BELL SYSTEM PRACTICES
Outside Plant Construction
and Maintenance

ADDENDUM G50.607.2
Issue 1, May, 1957
AT&T Co Standard

CABLE SPLICING—GENERAL

SOLID PIC CABLES

ARRANGEMENT OF UNITS
AHA (22 Ga), AKM (24 Ga) AND AKT (26 Ga) TYPES

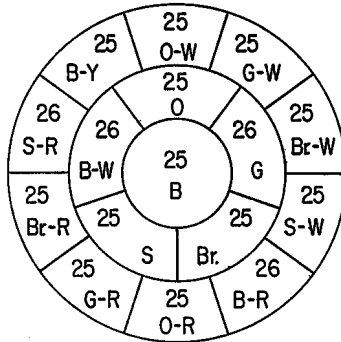
1.01 This addendum is issued to cover the core make-up of 404-pair (a new size) coded type, solid PIC cables of 22, 24, and 26-gauge.

2.01 The arrangement of the units and the color code of the binding strings are shown in the sketch on the following page.

2.02 The color code of the pairs in the individual 25 and 26-pair units is the same as that shown in the main section.
